# REQUEST FOR COUNCIL ACTION

DATE: 03-03-03
AGENDA SECTION: PUBLIC HEARINGS	ORIGINATING DEPT: PLANNING	ITEM NO.
ITEM DESCRIPTION: Land Subdivision Permit (preliminary plat) #03-02 by Payne Company to be known as Century Hills Seventh Subdivision. The Plat proposes to subdivide approximately 9.44 acres of land into 25 lots for single family development and proposes to dedicate right-of-way for a cul-de-sac roadway. The property is located south of 21 <sup>st</sup> Street NE, east of Century Hills First Subdivision, west of Shannon Oaks Subdivision and north of Century Hills Sixth Subdivision.		PREPARED BY: Theresa Fogarty, Planner

Land Subdivision Permit (Preliminary Plat) #03-02 by Payne Company to be known as Century Hills Seventh Subdivision. The Plat proposes to subdivide approximately 9.44 acres of land into 25 lots for single family development and proposes to dedicate right-of-way for a cul-de-sac roadway. The property is located south of 21st Street NE, east of Century Hills First Subdivision, west of Shannon Oaks Subdivision and north of Century Hills

PRELIMINARY PLA'

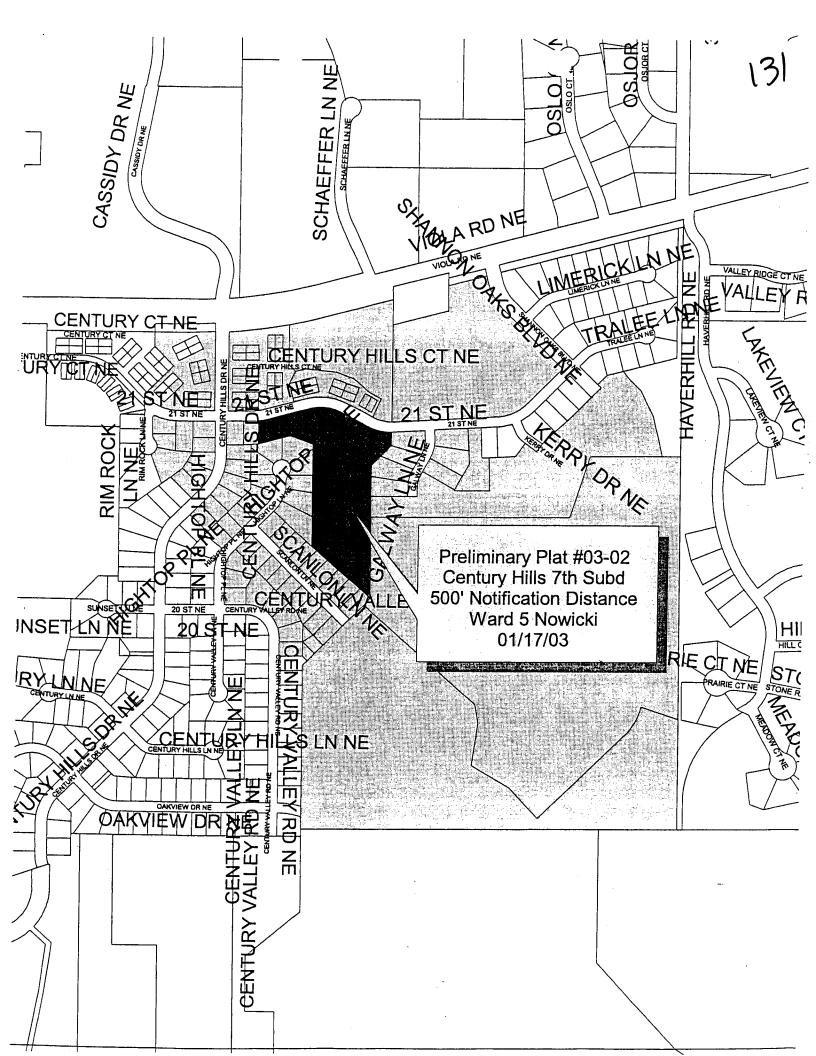
This plat proposes to dedicate one new right-of-way identified as "Street A". This roadway is designed with a 56' right-of-way ending in a cul-de-sac. The cul-de-sac appears to be less than 96 feet in diameter and shall be marked "No Parking" along the entire cul-de-sac.

This roadway needs a designation. It is recommended that the roadway be identified on the final plat as "Century View Lane NE".

In accordance with current City policy and the approved Development Agreement pedestrian facilities will be required along both side of the proposed cul-de-sac and the entire frontage of the south side of 21<sup>st</sup> Street NE.

Dedication of an off-site drainage easement to point discharge stormwater between Lots 9 & 10 is required prior to recording the Final Plat for this development.

1. Roadway illustrated as STREET A needed a designation. Called Yaggy Colby and spoke with Denny Christopherson, we came up with CENTURY VIEW LANE NE for the roadway designation.

Cul-de-sacs less than 96 feet in diameter shall be marked "No Parking" along the cul-de-sac. The cul-de-sac associated with this plan is indicated as less then 96 feet and therefore shall be marked "No Parking".

- 1. At the time of Final Plat submittal:
  - a. Change the roadway designation of "Street A" to "Century View Lane NE".
- 2. Dedication of parkland shall be met via: Deferred land dedication, as recommended by the City Park & Recreation Department in the attached memo, dated January 17, 2003.

- 3. Prior to recording the Final Plat for this development, the dedication of an off-site drainage easement to point discharge stormwater between Lots 9 & 10, shall be required.

- 4. The cul-de-sac associated with this plan is indicated as less than 96 feet and shall be posted "No Parking" along the entire length of the cul-de-sac.

- 5. Pedestrian Facilities shall be constructed, at the Developer's expense, along both sides of the proposed cul-de-sac and the entire frontage of the south side of 21<sup>st</sup> Street NE.

RECOMMENDATION: Change the roadway designation on Final Plat to CENTURY VIEW LANE NE.
